**Planning Proposal for 'Allfarthing' – 2 Brisbane Grove Rd, Goulburn (REZ/0003/2122)
(PP_2021_6932) -Pre-Gateway Referral**

ATTACHMENT 1 - DETAIL

Map 1. SLWCA Unsewered Residential development (lots 4,000 m² to 2 ha) for 'Allfarthing', 2 Brisbane Grove Rd Goulburn

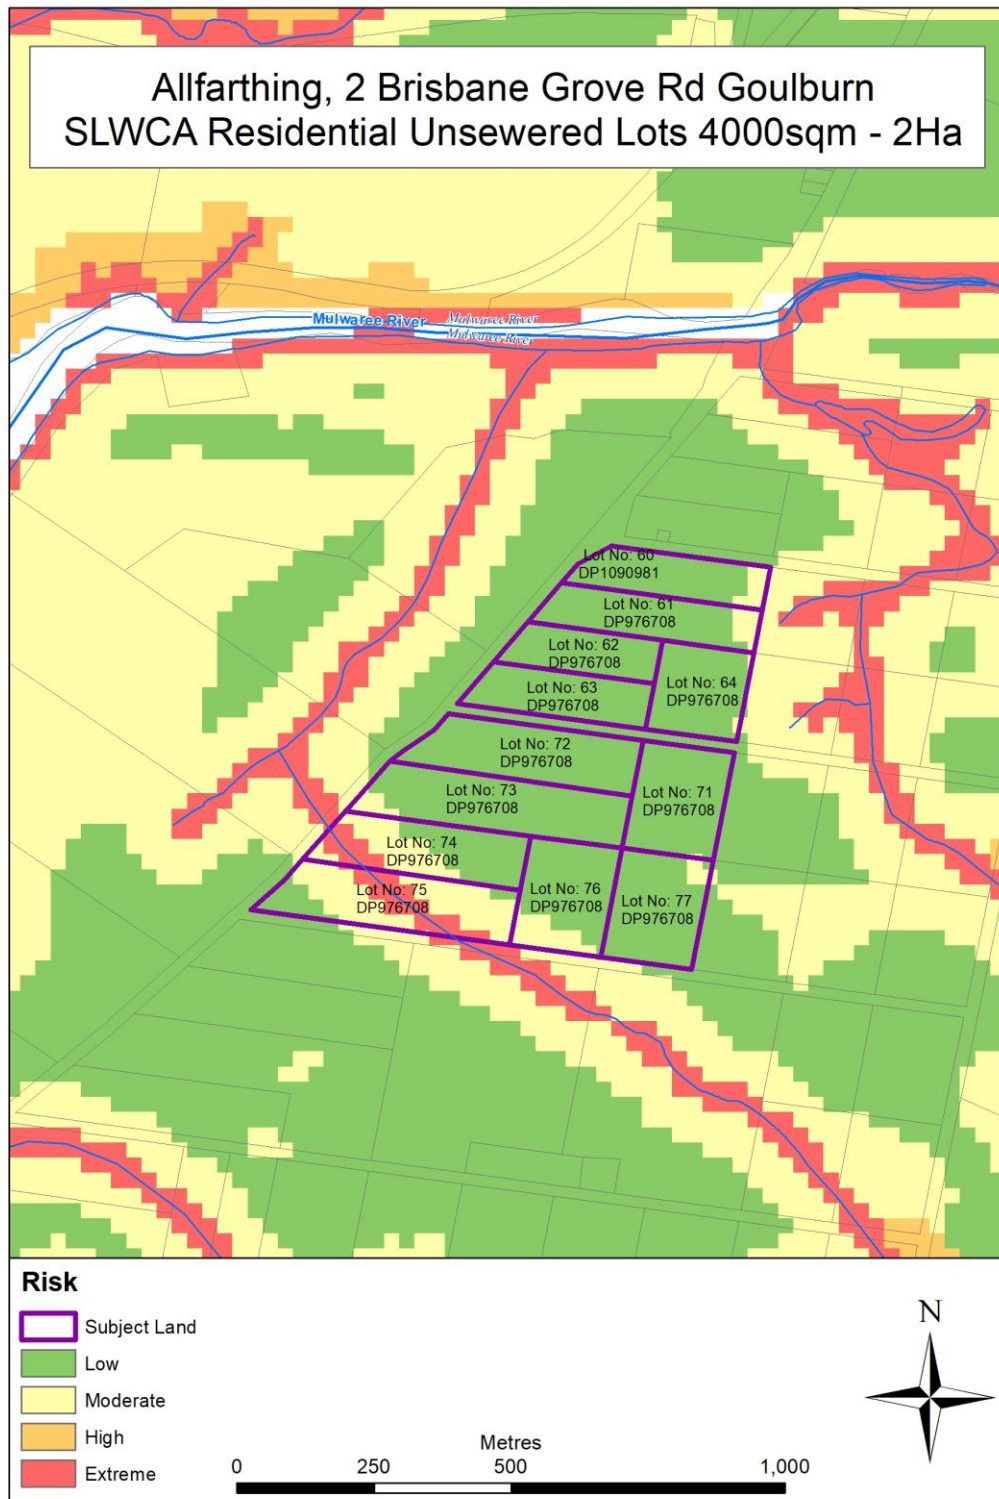
WaterNSW has prepared a Strategic Land and Water Capability Assessment (SLWCA) for the site. The most applicable SLWCA is for unsewered residential lots (4,000 sqm – 2 ha). The outcomes of the SLWCA is presented in Attachment 2. The SLWCA shows that the water quality risk to the site varies from LOW to EXTREME. The areas classified as EXTREME are associated with the watercourse affecting land in the south-west corner of the site. Most of the northern area of the site carries a LOW water quality risk. Areas of LOW risk generally have a HIGH capability for unsewered development while areas of EXTREME risk have a VERY LOW capability. We encourage unsewered development to be located in areas of LOW to MODERATE risk.

Please note that the variables influencing the outputs of the SLWCAs include distance to water courses, but do not include flooding risk.
